Access Compliance Report

Public Rights-of-Way

Intersection ID: 10034319	Main Street: PERIMETER_PY	Cross Street: N/A	Location: NW
ADA ID: 80698AA21D32	Ramp Type: PerpDiag	Initial Pass/Fail: Fail	Overall Compliance: No
		Severity Score: 10

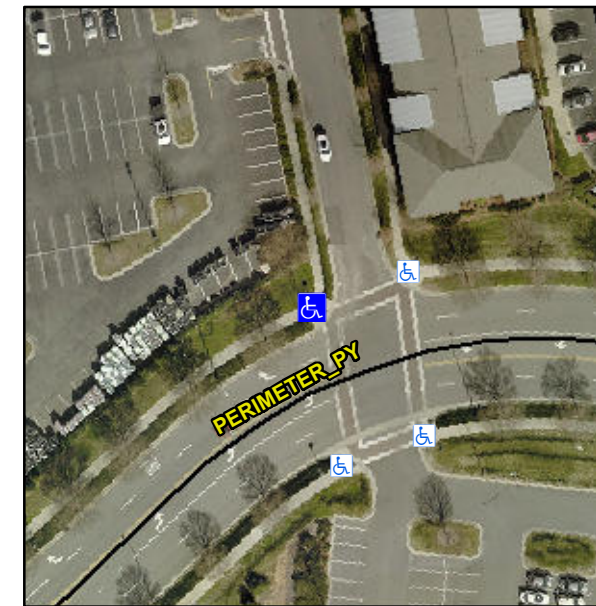
Not Found, R304.5.1, R304.5.3

Compliance	Description	Data	Compliance	Description	Data
N/A	Ramp Length (in)	67.0	Yes	Ramp Slope (%)	8.2
No	Ramp Width (in)	47.0	No	Ramp XSlope (%)	2.9
N/A	Flare Type LT	N/A	N/A	Flare Type RT	N/A
N/A	Flare Slope LT (%)	N/A	N/A	Flare Slope RT (%)	N/A
N/A	Flare Traversable LT?	N/A	N/A	Flare Traversable RT?	N/A
N/A	Landing Length (in)	N/A	N/A	DWS Provided?	N/A
N/A	Landing Width (in)	N/A	N/A	DWS Contrast?	N/A
N/A	Landing Slope (%)	N/A	N/A	DWS Length (in)	N/A
N/A	Landing X Slope (%)	N/A	N/A	DWS Full Width?	N/A
N/A	Landing Curb? (Y/N)	N/A	N/A	DWS Offset (in)	N/A
N/A	Shared Landing?	N/A			
N/A	Gutter Ponding?	N/A	N/A	Gutter Slope (%)	N/A
N/A	Gutter Lip Ht (in)	N/A	N/A	Gutter X Slope (%)	N/A
N/A	Painted X Walk1?	Yes	N/A	Painted X Walk2?	Yes
	X Walk 1 Direction	To S		X Walk 2 Direction	To E
N/A	X Walk 1 Width (in)	72.0	N/A	X Walk 2 Width (in)	72.0
	X Walk 1 Slope (%)	1.8		X Walk 2 Slope (%)	0.4
	X Walk 1 X Slope (%)	2.7		X Walk 2 X Slope (%)	0.8

Remove & Replace Curb Ramp With Two New Directional Ramps or Equivalent.
